**FINAL**  
**Data Gap Analysis**  
**North Hollywood Operable Unit**  
**Second Interim Remedy**  
**Groundwater Remediation System Design**  
**Revision 1**  
**March 14, 2012**

# Final Data Gap Analysis

## North Hollywood Operable Unit Second Interim Remedy Groundwater Remediation System Design

### Revision 1

FIGURE  
**4-7a**

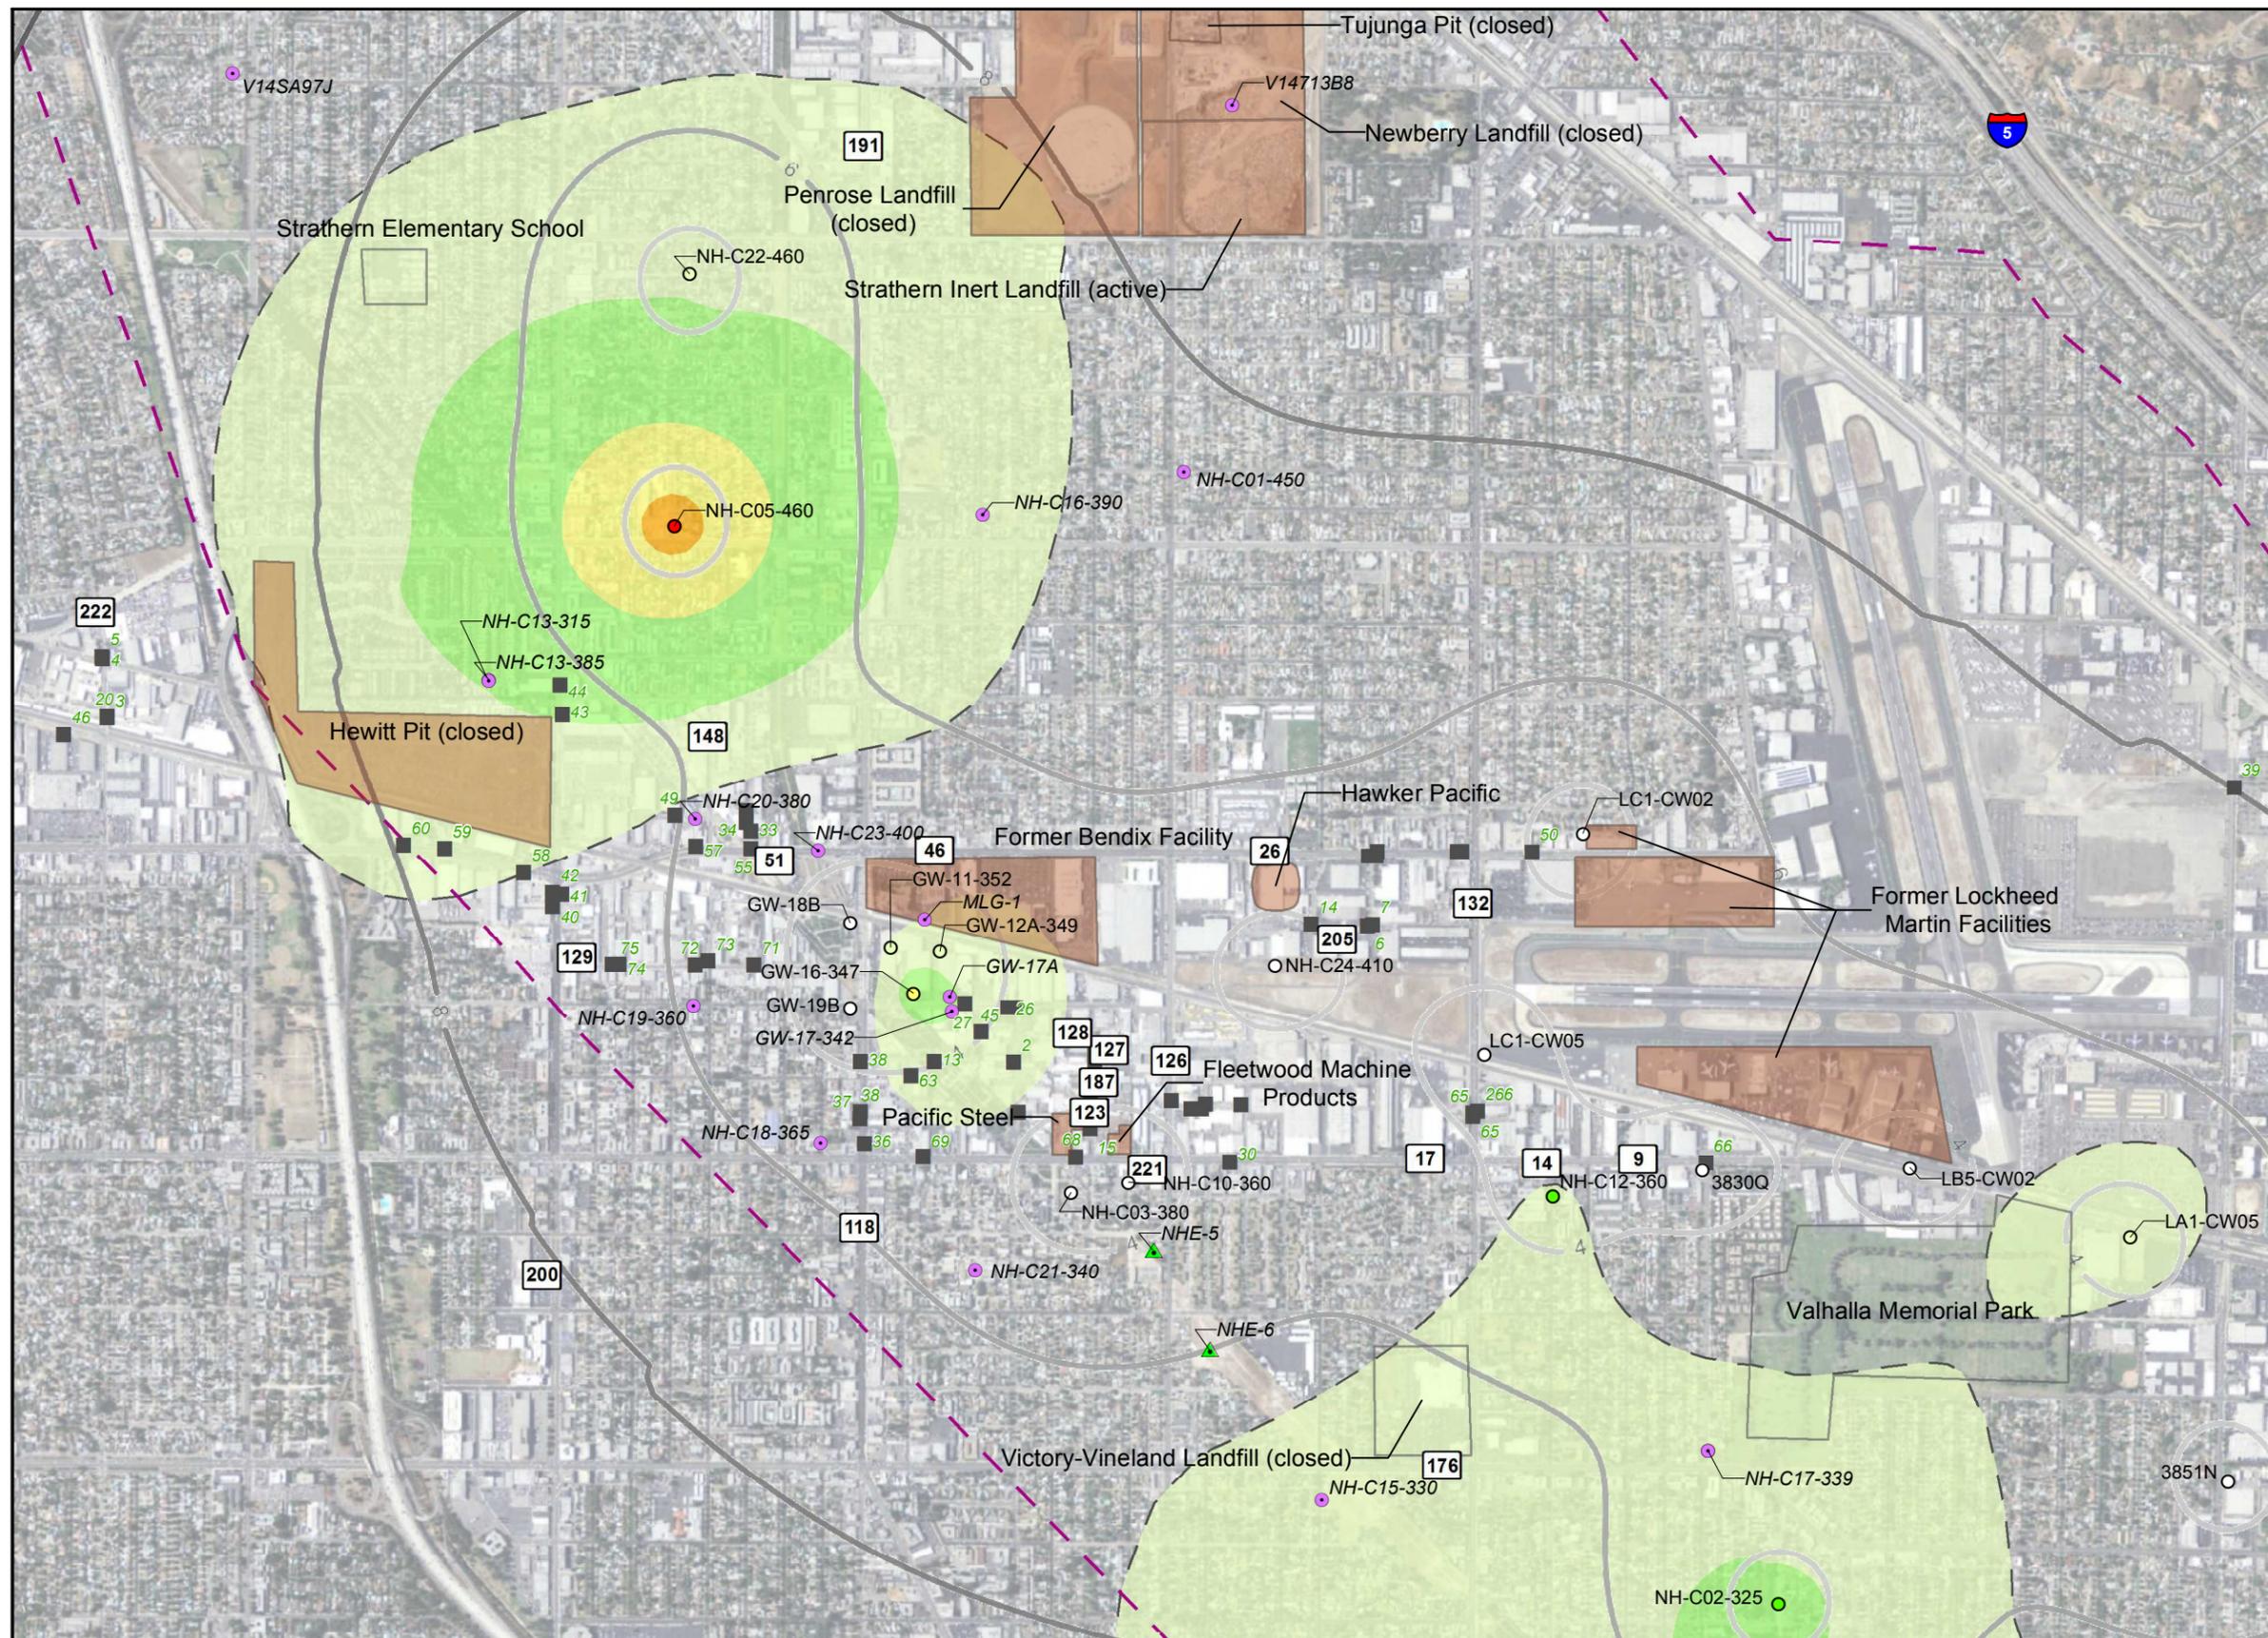
**AMEC response:** As contoured on Figure 4-7a, lower TCE concentrations separate these wells from higher concentrations beneath the former Bendix facility. This is particularly true of the 100 µg/L TCE concentration observed at NH-C10-280. Based on FFS modeling results (see Figure 4-11 therein), these wells are expected to be hydraulically isolated from the former Bendix facility due to upgradient capture by NHE-2 and NHE-3. Additional depth-discrete sampling recommended in the draft Data Gap Analysis (Section 6.1.1) is intended to be used to further delineate COC distribution and consider other potential sources in this area.
